PLANS OF PROPOSED MIDWAY DRIVE PICARDY AVENUE TO CONSTANTIN BLVD CITY PARISH PROJECT No. 20-CP-HC-0008

**SUMMARY OF ESTIMATED QUANTITIES**

**CHANGE ORDER AND/OR SPECIAL AGREEMENT**

SHEET NUMBER	4A
PROJECT	EAST BATON ROUGE PARISH
CITY PROJECT	20-CP-HC-0008
STATE PROJECT	
DESIGNED	
CHECKED	
DATE	1 OF 12
REVISION DESCRIPTION	
NO.	
DATE	
BY

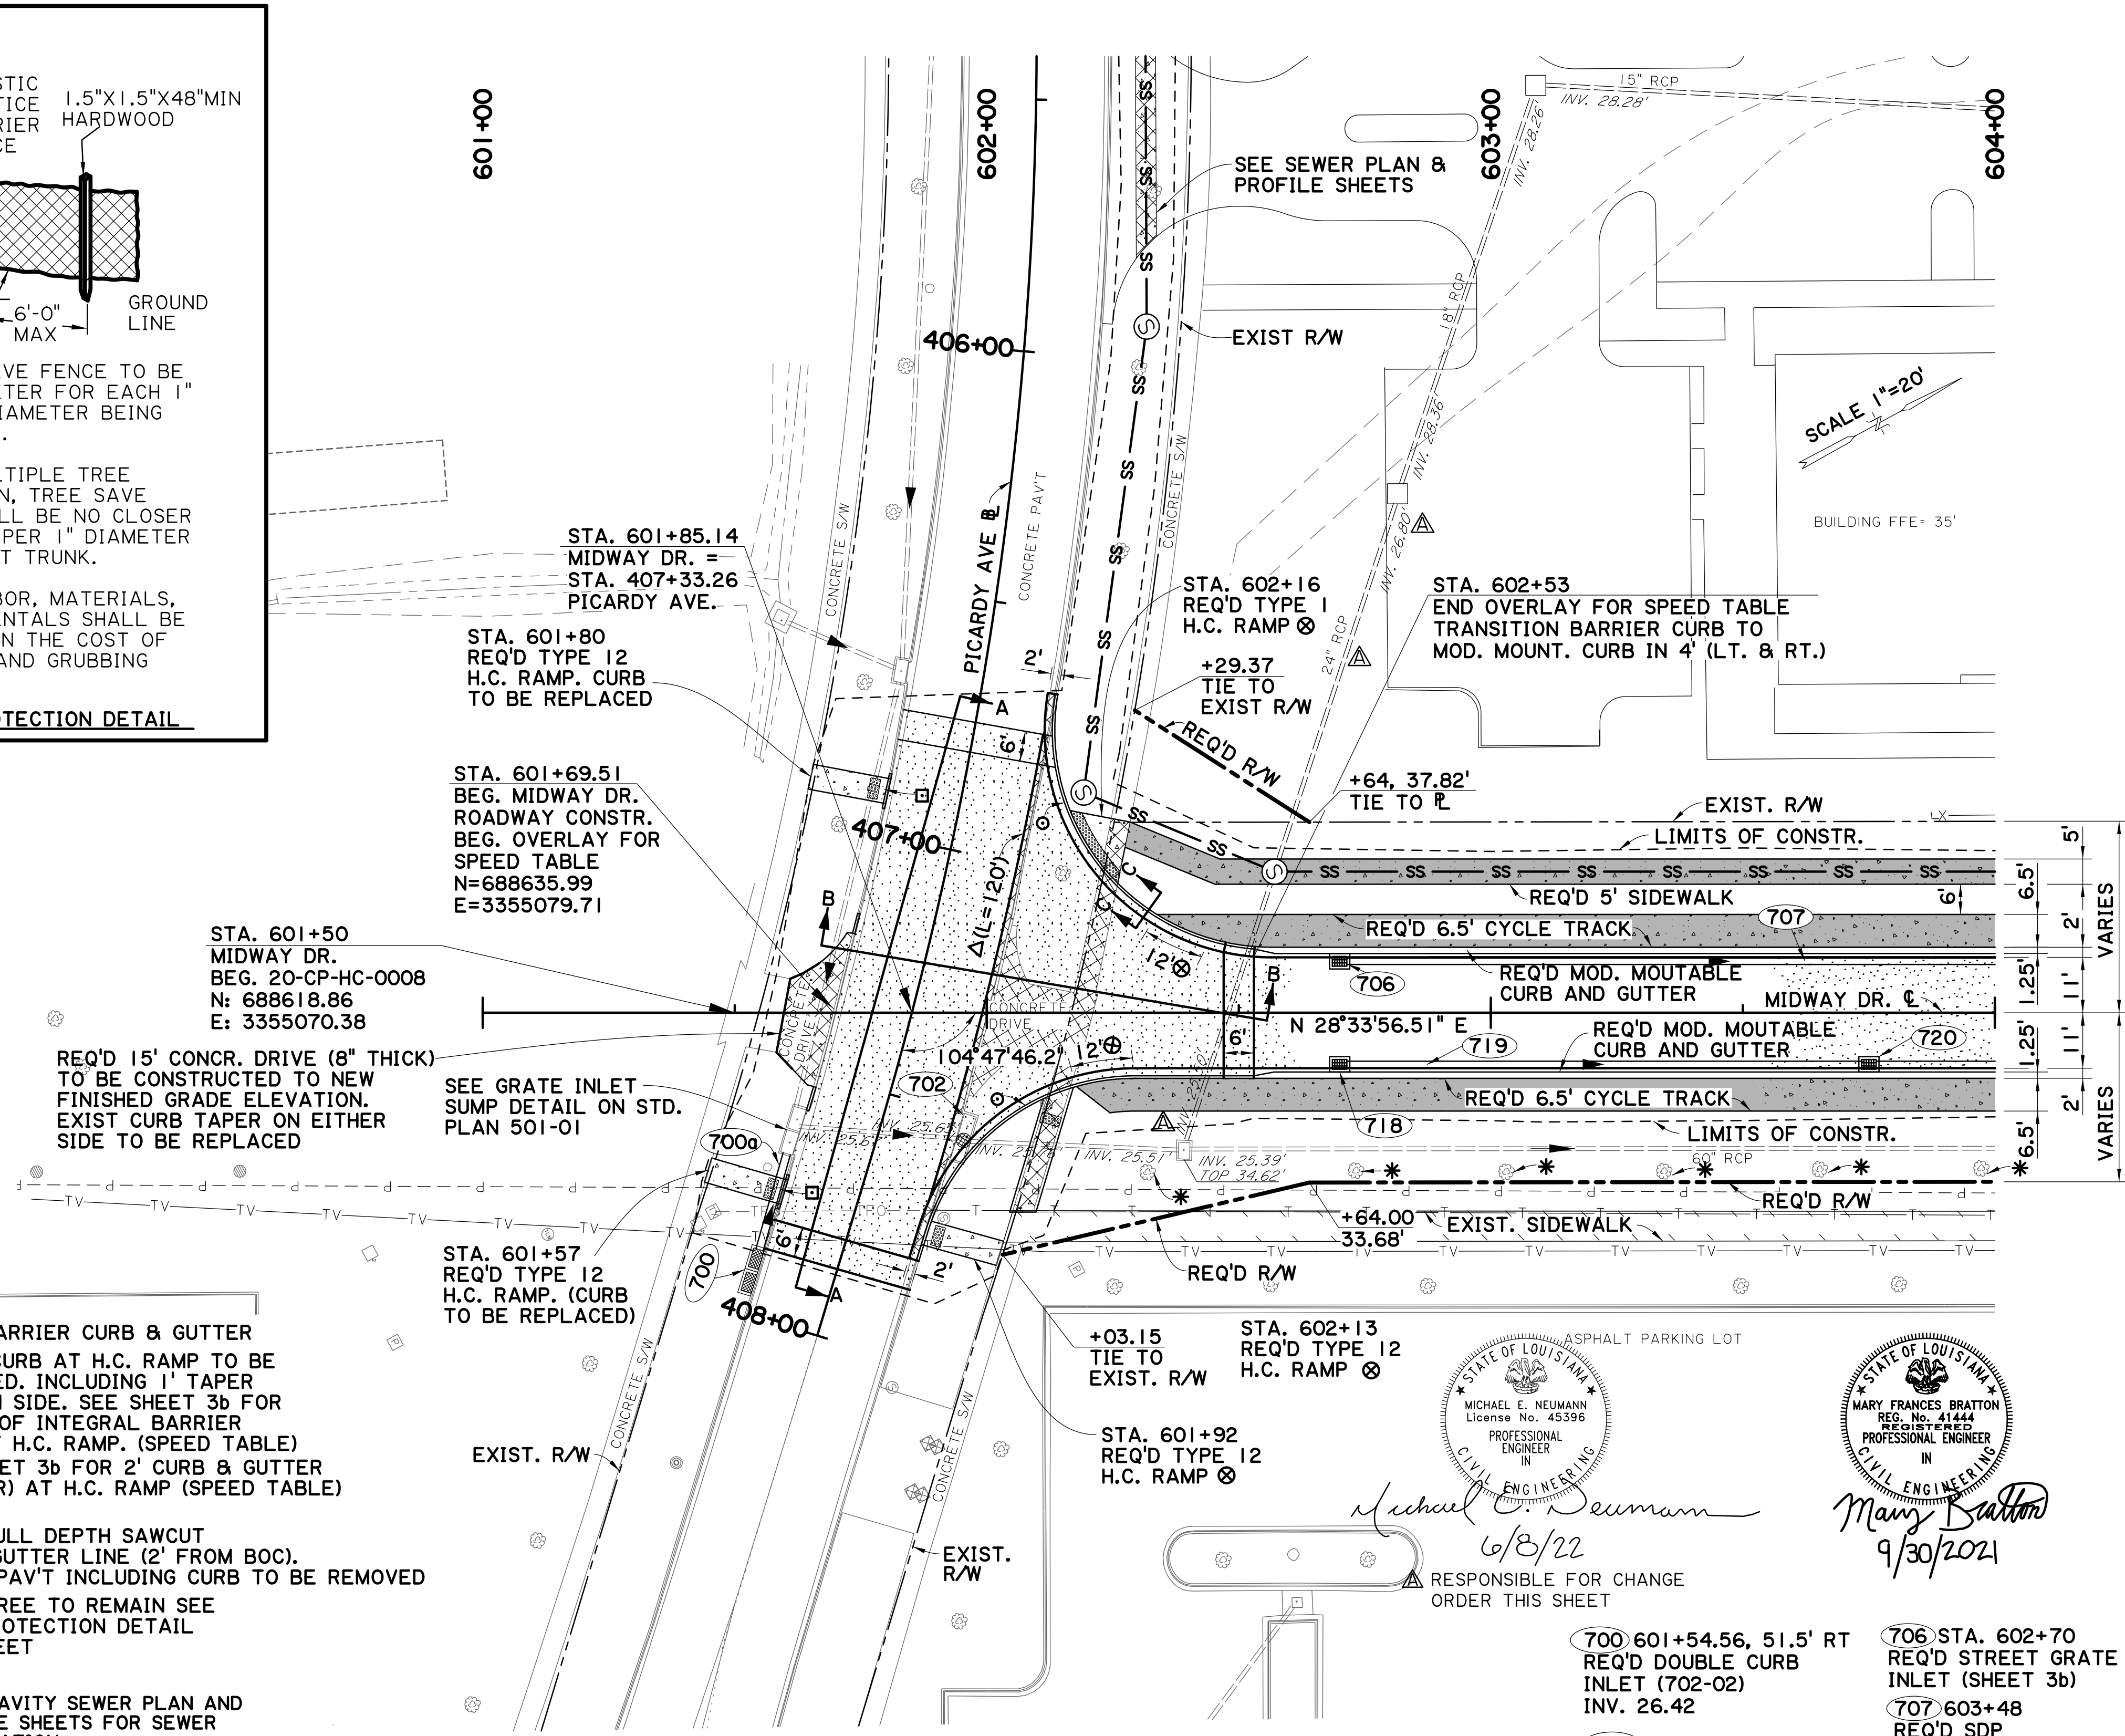
5-17-22 REVISED INVERTS & PIPE SIZES, & REMOVAL TABLE

- 700 601+54.56, 51.5' RT REQ'D DOUBLE CURB INLET (702-02) INV. 26.42
- 700 601+58 REQ'D SDP 18" X 21" @ 0.15%
- 702 601+99 ADJUST EXIST. CB TO DRAIN MANHOLE INLET (702-51) TOP EL. 35.16
- 706 STA. 602+70 REQ'D STREET GRATE INLET (SHEET 3b)
- 707 603+48 REQ'D SDP 15" X 153" @ 0.62%
- 718 602+70 REQ'D STREET GRATE INLET (SHEET 3b)
- 719 603+23 REQ'D SDP 15" X 103" @ 0.62%
- 720 603+75 REQ'D STREET GRATE INLET (SHEET 3b)

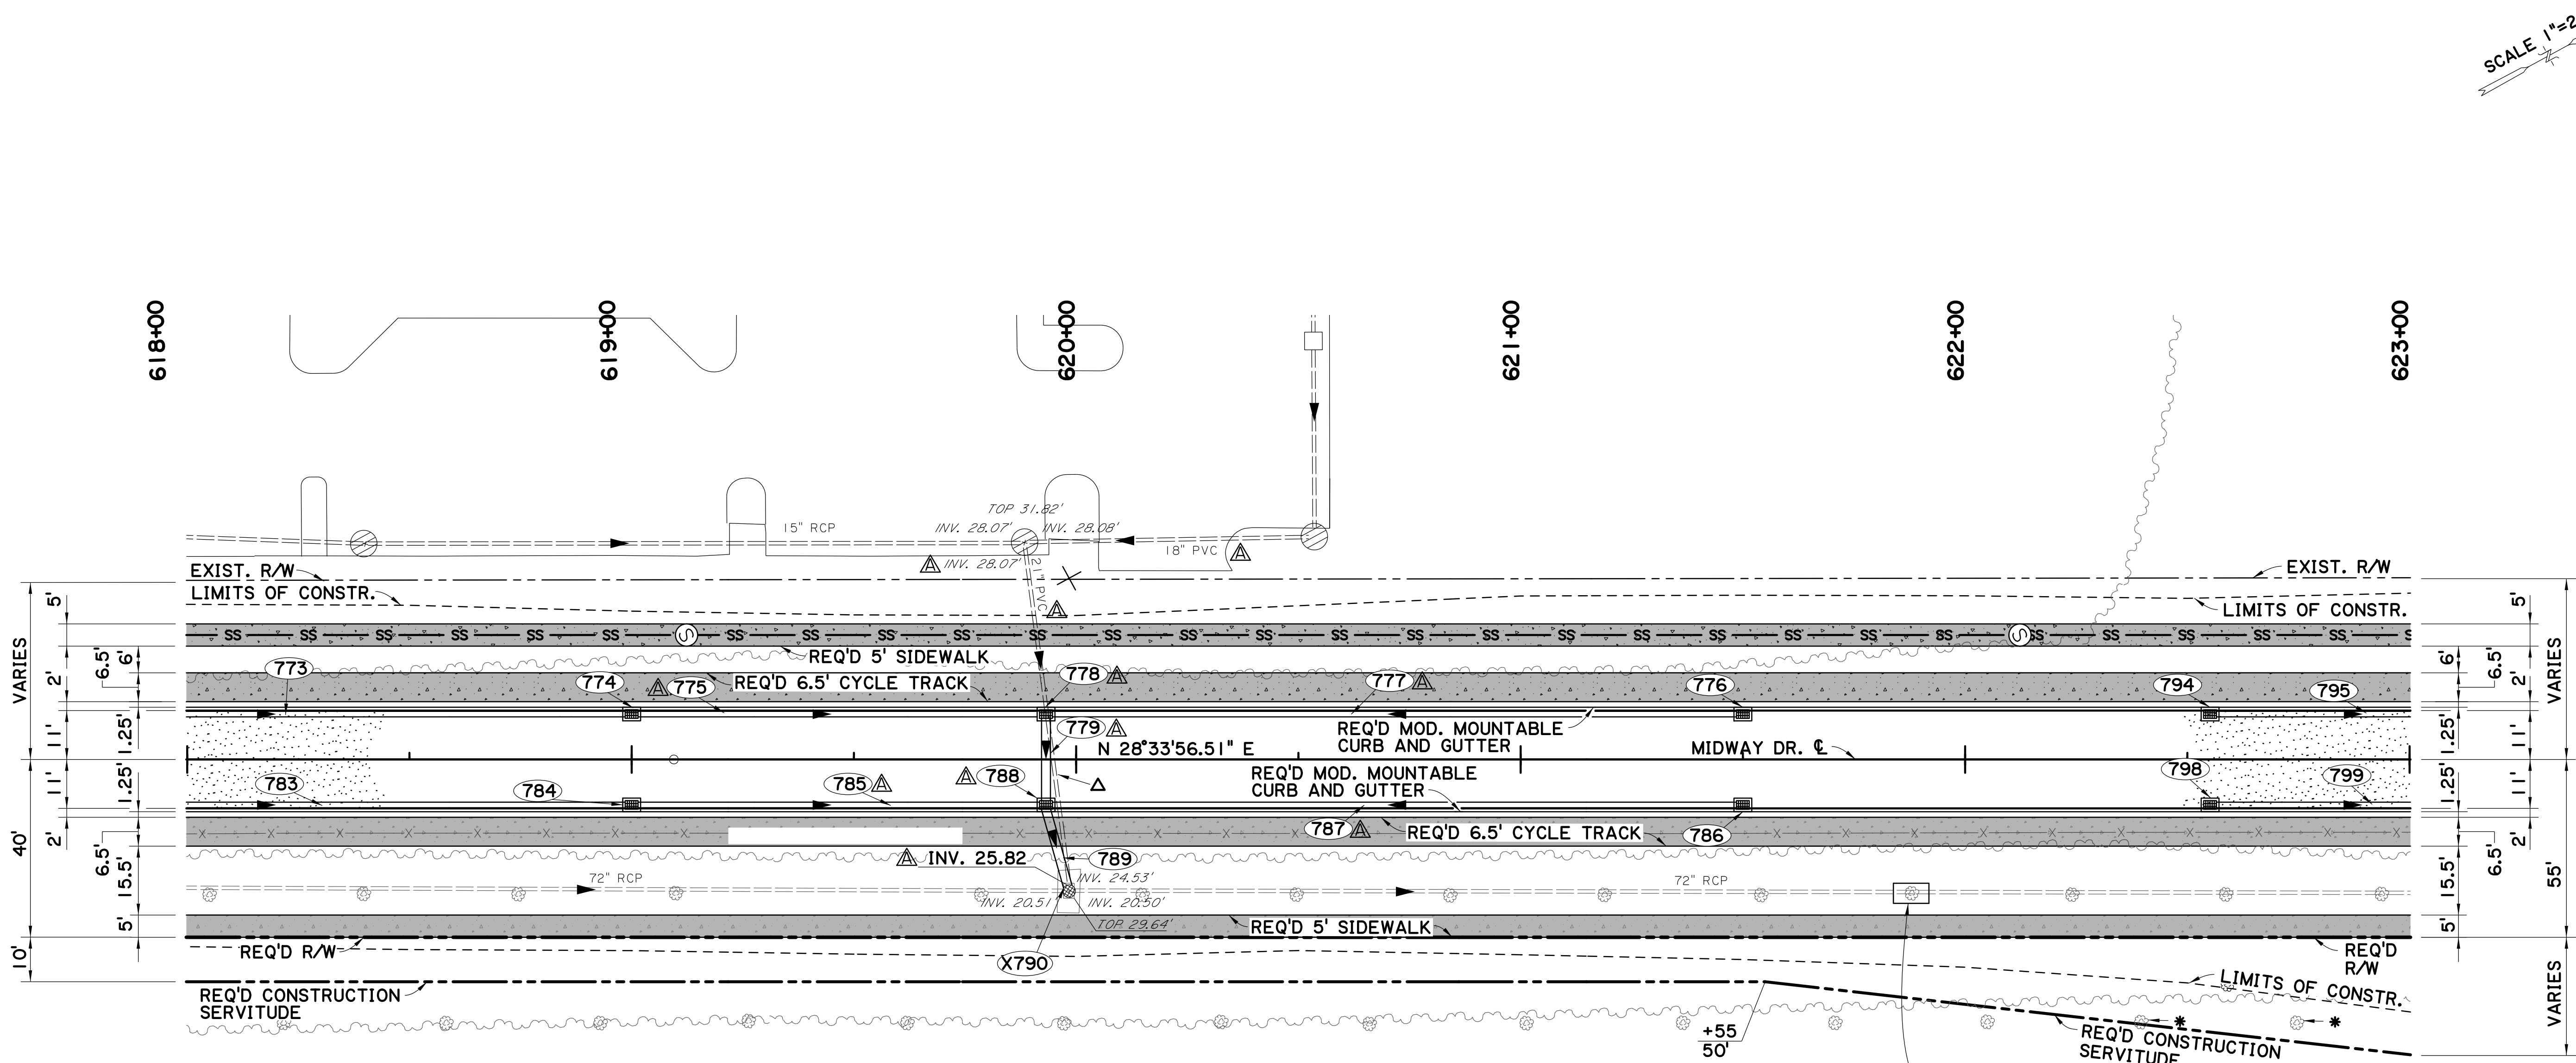
SHEET NUMBER		IIA	
DESIGNED: MFB		EAST BATON ROUGE PARISH	
CHECKED: GDH		CITY PROJECT	
DETAILED: DTA		20-CP-HC-0008	
CHECKED: MFB		STATE PROJECT	
DATE		8 OF 12	
NO.		BY	
5-17-22		ADDED PIPE; ADDED EXIST. 24" PIPE; UPDATED EXIST. GROUND LINE & ELEVATION	
NO.		DATE	
NO.		REVISION DESCRIPTION	
NO.		DATE	
NO.		BY

△ REMOVE 21" PVC PIPE FROM STR. X790 TO STR. 778 (APPROX 43' OF PIPE)

△ REMOVE & REPLACE 8' SEGMENT OF EXIST. 72" PIPE WHERE GROUND HAS SUNKEN.

778 STA. 619+93  
REQ'D STREET GRATE  
INLET (SHEET 3b)  
TO BE BUILT AROUND  
EXIST. PIPE

779 STA. 619+93  
REQ'D SDP  
24" x 20' @ 0.15%

SHEET NUMBER	15A
PARISH	EAST BATON ROUGE PARISH
CITY PROJECT	20-CP-HC-0008
DESIGNED	MFB
CHECKED	GDH
DATE	12 OF 12
REVISION DESCRIPTION	
NO.	
DATE	
BY

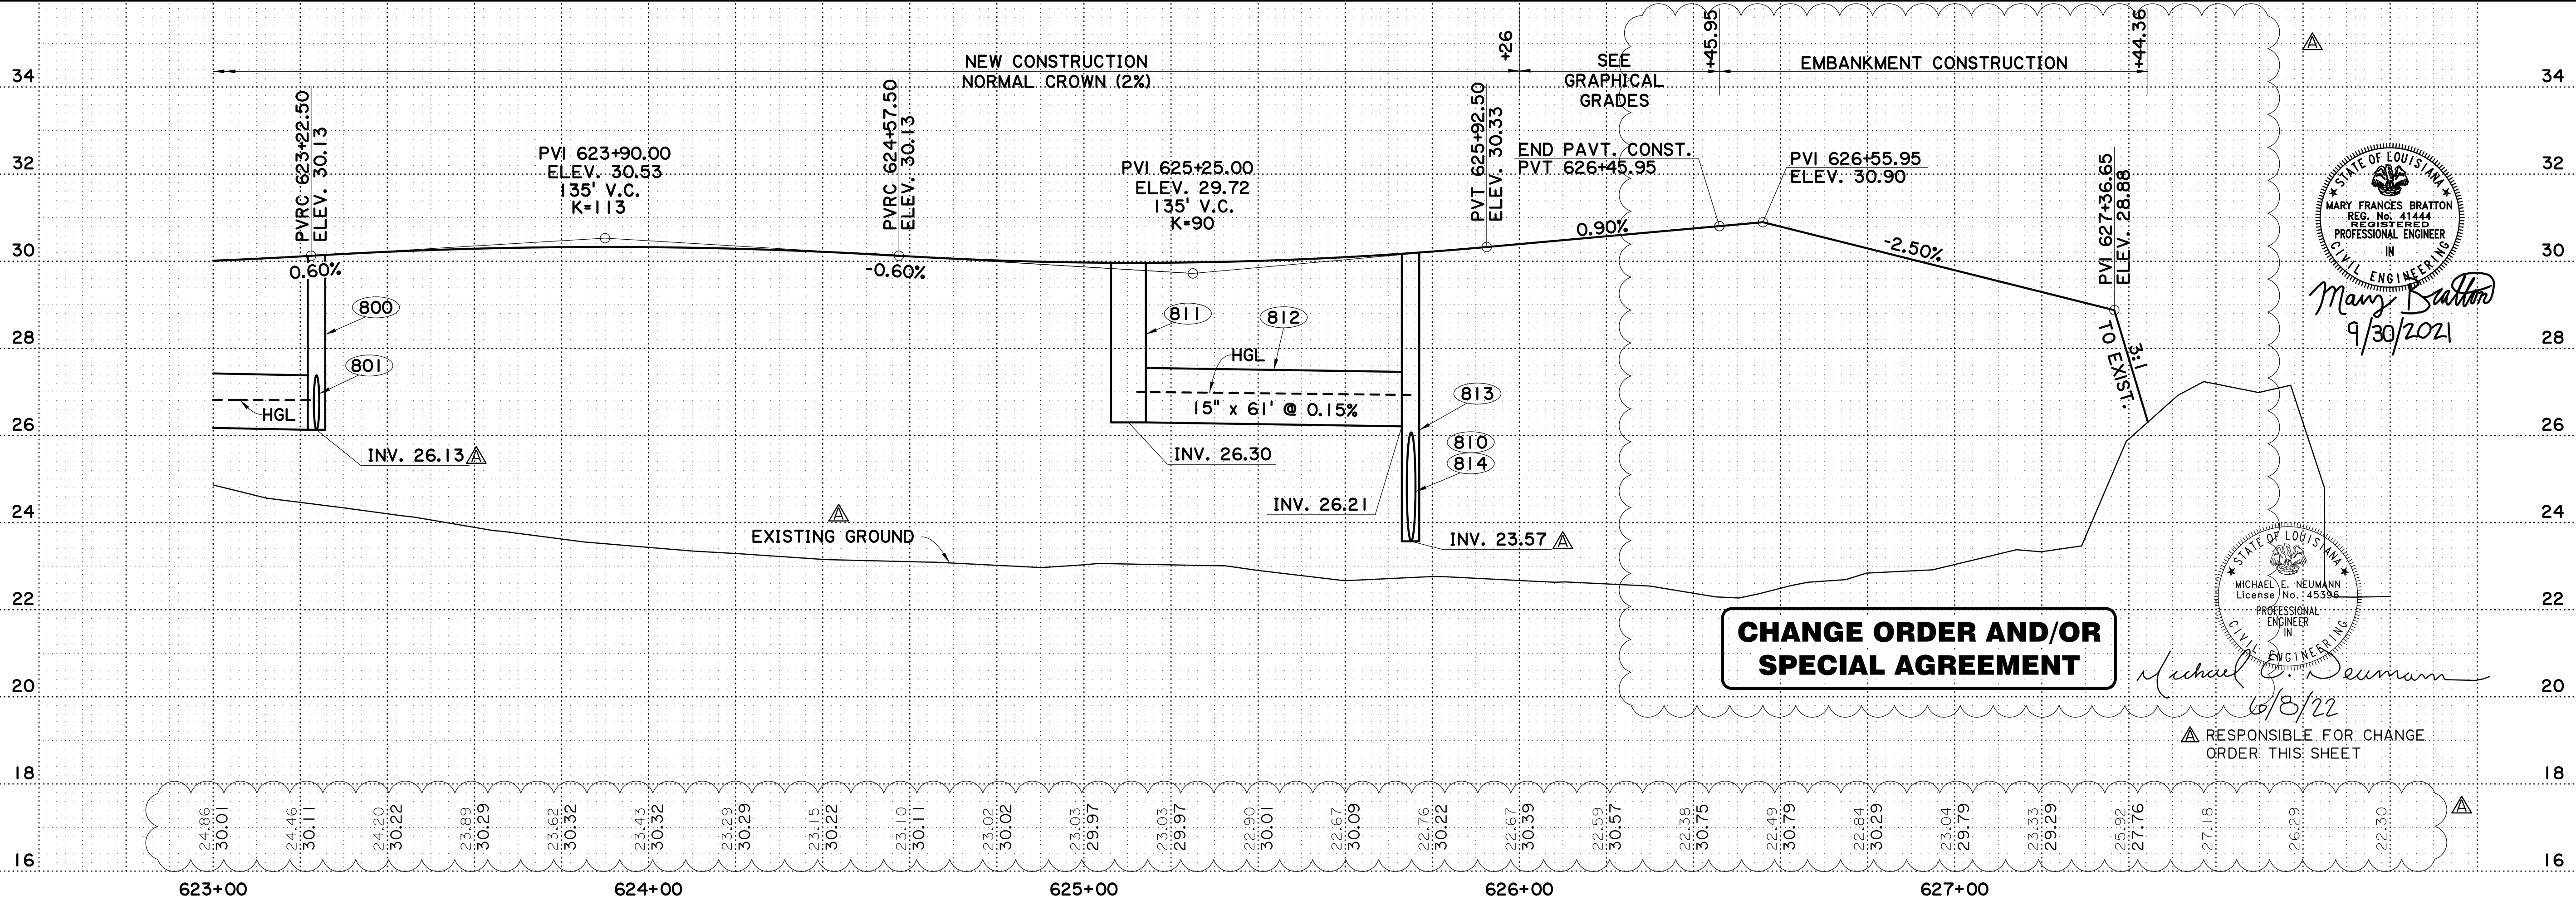
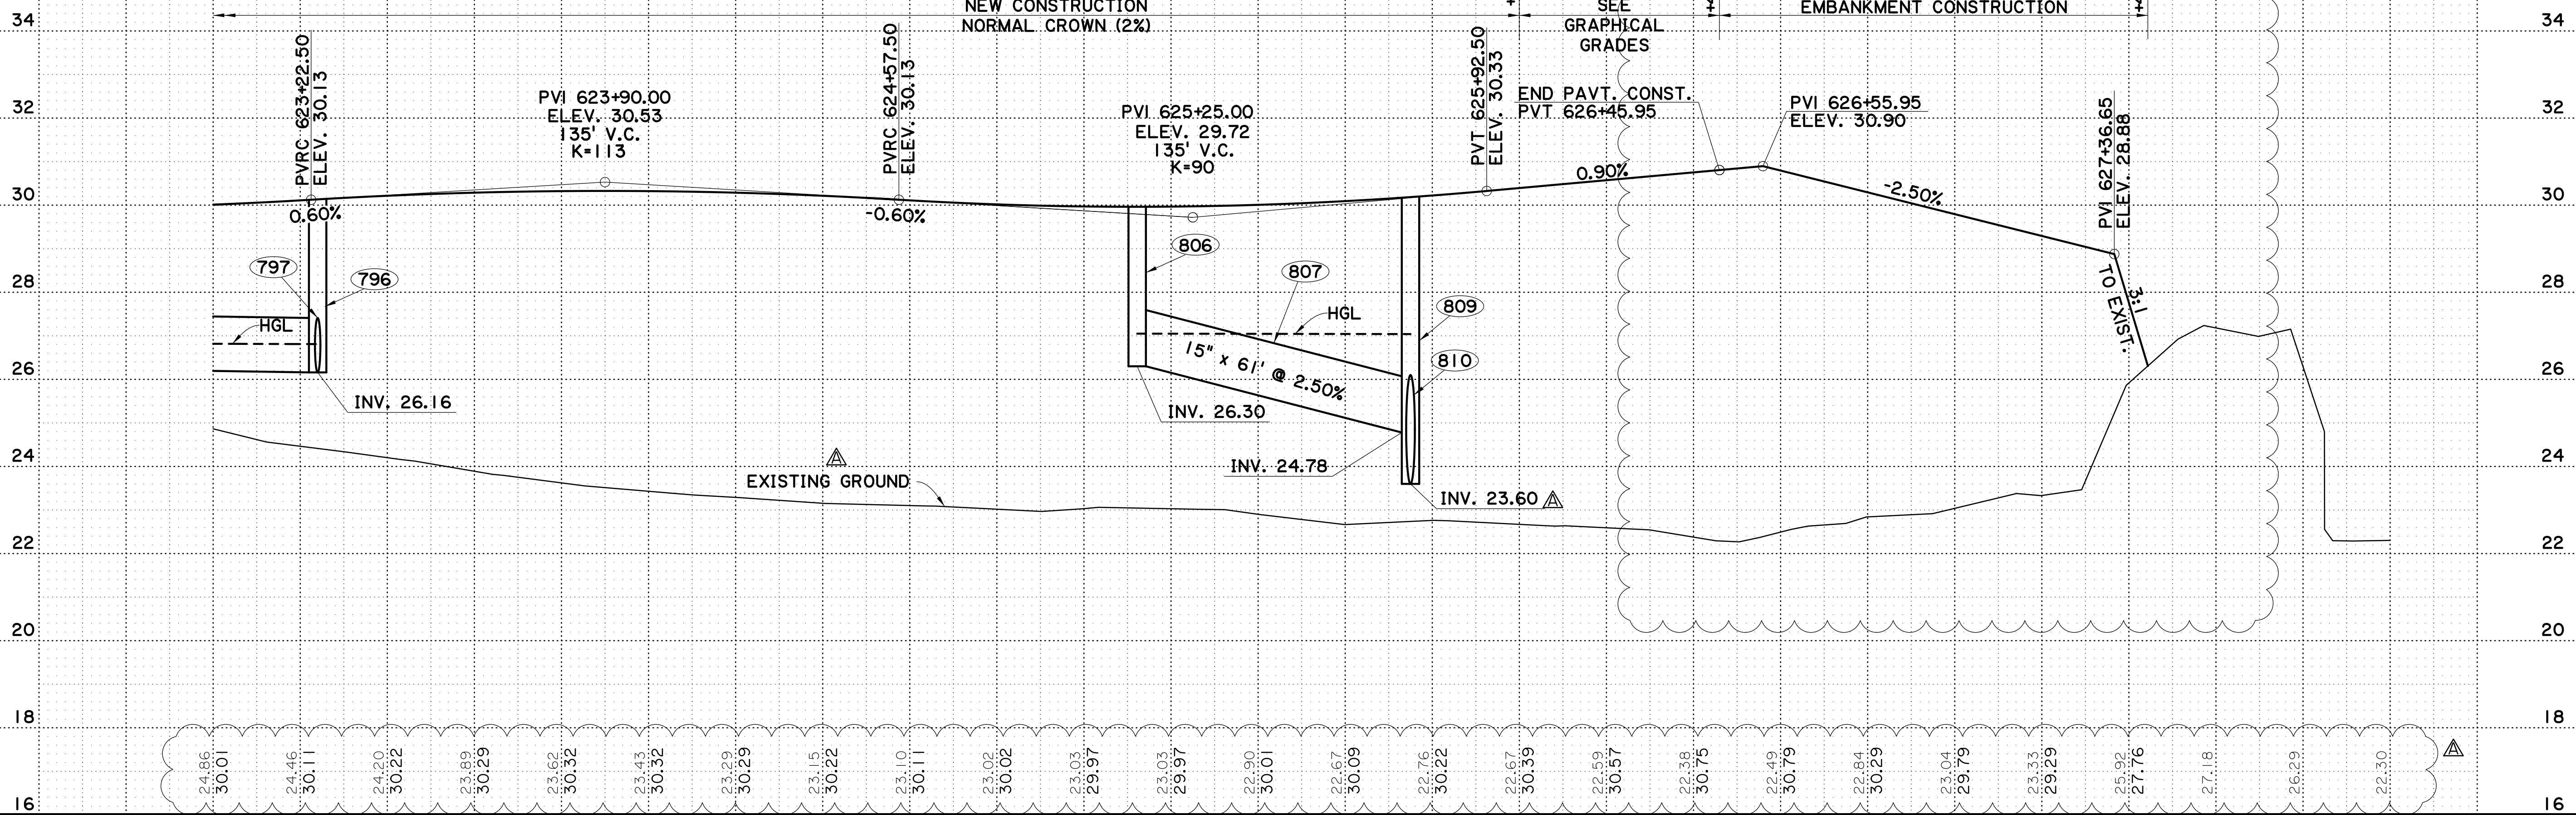
5-17-22 UPDATED EXIST. GROUND LINE & ELEVATION; UPDATED INV.; REVISED EARTHWORK TO EXTEND THROUGH CONSTANTIN INTERSECTION
